**SUBJECT:** CHANGE ORDER REQUEST - Augusta Reservoir Dams Improvements Project

# CONSTRUCTION CONTRACT CHANGE ORDER

**PROJECT TITLE** Augusta Reservoir Dams Improvements Construction Project

## Change Order No. One Proposal

| DRAWING No. | C300 |

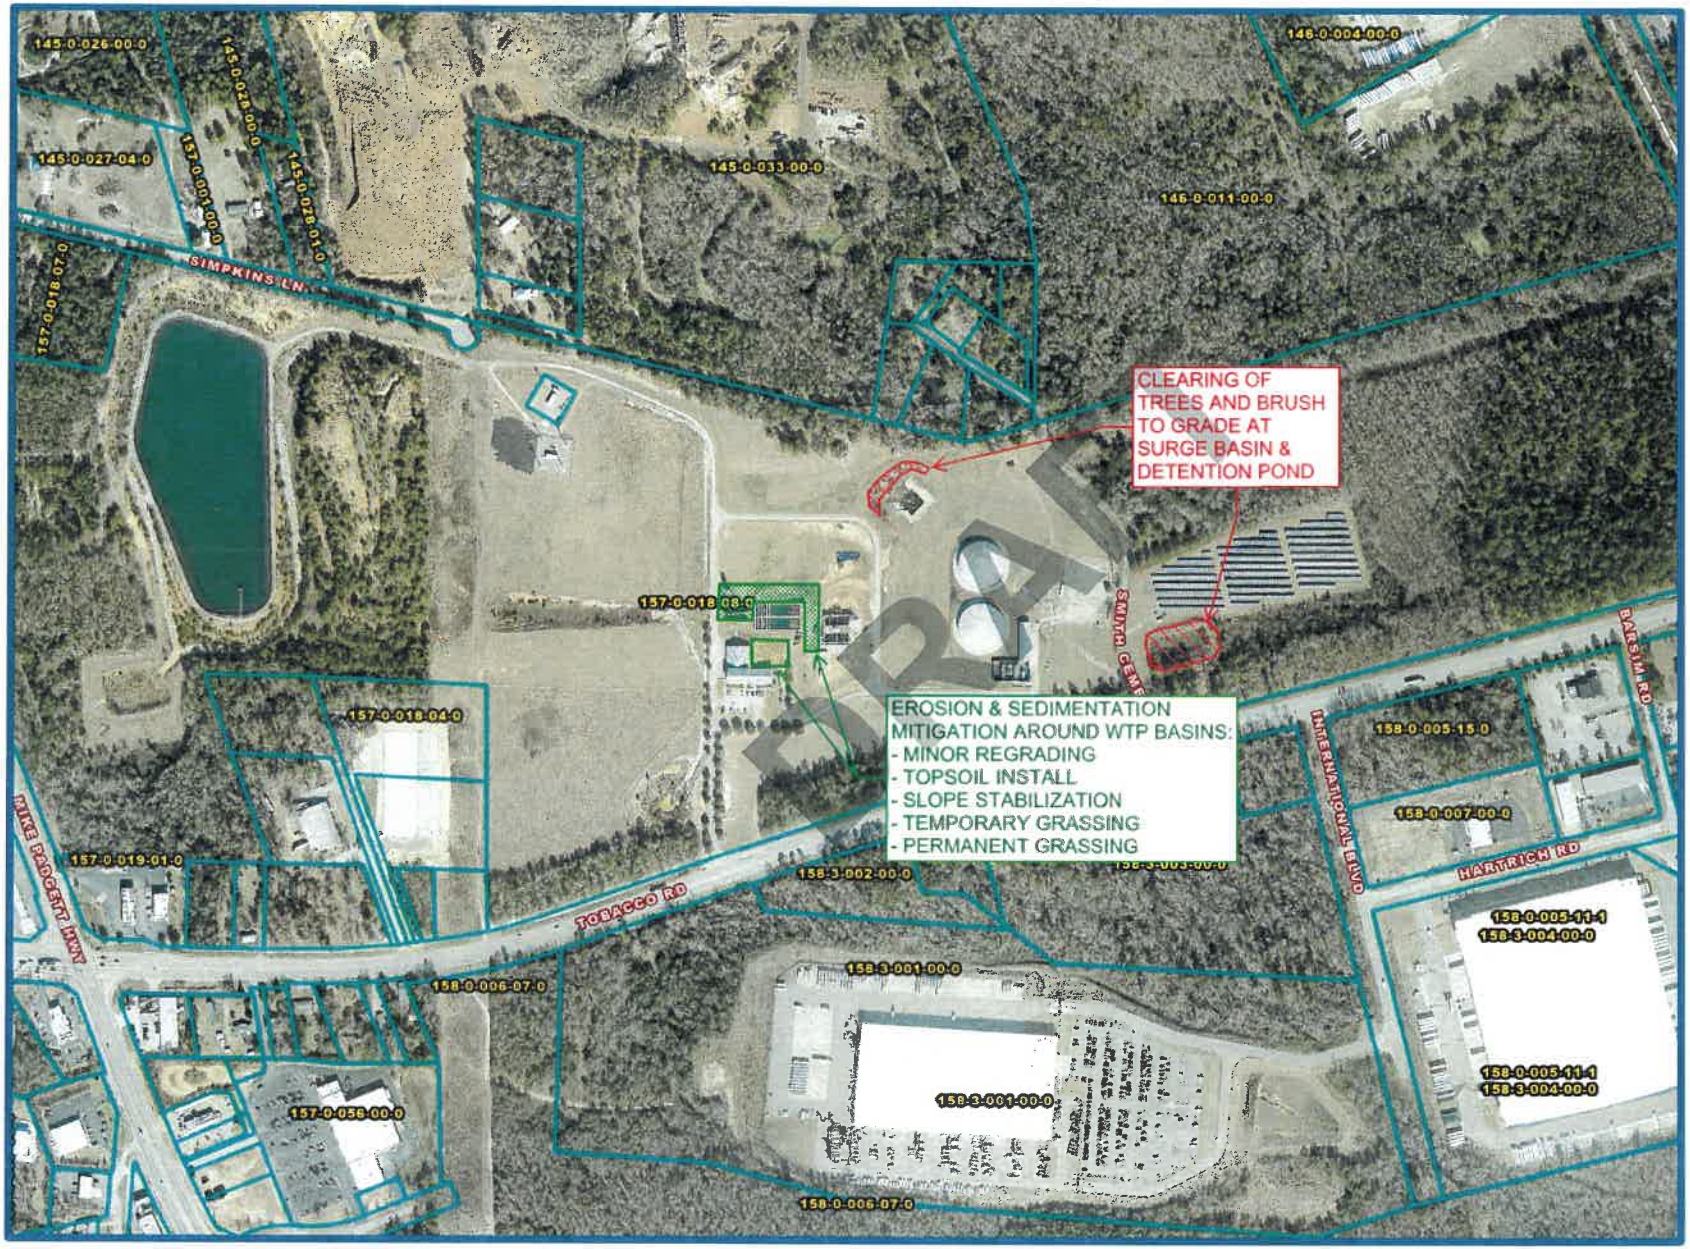
1. Installation of security fencing at the Highland Avenue Water Treatment Plant Reservoirs to provide security to the reservoir embankment and privacy to the adjacent properties;

2. Performance of a slope stability analysis for the Highland Avenue Water Treatment Plant Reservoirs as required by the facility's dam regulators at the GA EPD Safe Dams Program;

| PAY ITEM | DESCRIPTION | QTY | UNITS | UNIT COST | TOTAL COST |
|---|---|---|---|---|---|
| CO1-1 | REMOVE EXISTING SECURITY FENCING | 2640 | LF | $ 12.00 | $ 31,680.00 |
| CO1-2 | INSTALL PRIVACY FENCING (INCLUDES TIE TO EXISTING RESIDENTIAL FENCING WHERE APPLICABLE) | 2800 | LF | $ 73.00 | $ 204,400.00 |
| CO1-3 | INSTALL 16-FT CHAINLINK DOUBLE GATE | 4 | EA | $ 2,500.00 | $ 10,000.00 |
| CO1-4 | REMOVE EXISTING RESIDENTIAL FENCING/WALLS | 1000 | LF | $ 20.00 | $ 20,000.00 |
| CO1-5 | PERFORM ADDITIONAL CLEARING AND GRUBBING, GRASSING NORTHEAST OF WATER TOWER | 0.3 | AC | $ 40,000.00 | $ 12,000.00 |
| CO1-6 | [M-9] MIDSLOPE PIEZOMETERS REMOVED | -3 | EA | $ 3,000.00 | $ -9,000.00 |
| CO1-7 | SLOPE STABILITY ANALYSIS | 1 | LS | $ 70,768.00 | $ 70,768.00 |
